FITTING - HULL - KEEL TRUSS - BLADE FORG

DRAWING NO. 29A171

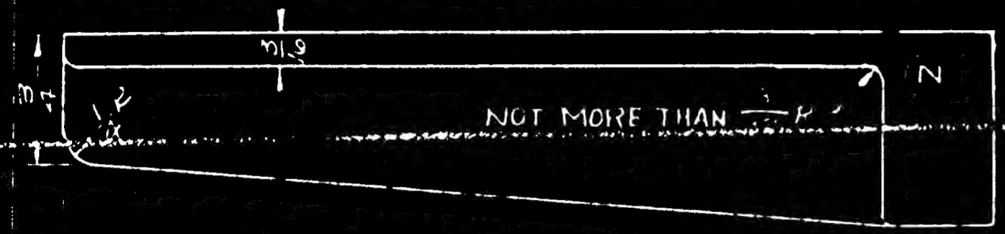
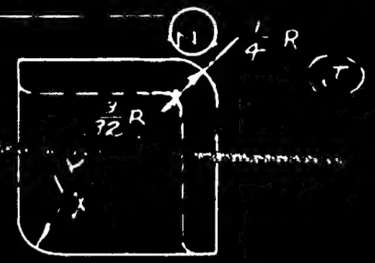
(FORGING NOT AFF)		
N	1/4 R WAS 3/32 R, REMOVED 3/32 R (2 PLACES) AFTER 1/4 R (1 PLACE) B29 4 L. GRAIN

CONVERTED 1/8" WALL CAG NEG		
	ADDED GES; UT FROM GS 0000 R		
	SPEC FROM QQ A367-70 GG		
	M 1017 TO 4GA7 GR3 & AC	(FORGING NOT AFF)	
	ASIST: NAVY SPEC FROM		
L	CHGD MAT'L FROM 14ST TO		
	[illegible]		
J	ADDED 3/32 R.	3-26-40	[illegible]
H	REMOVED DRAFT NOTE ADDED LIMITS	11-10-35	OVREN
G	MATL SPEC WAS .76A7	11-25-35	JAFFE
F	[illegible]		
E	BEGUN TO DATE & TRACED	2-28-34	M.E.A.
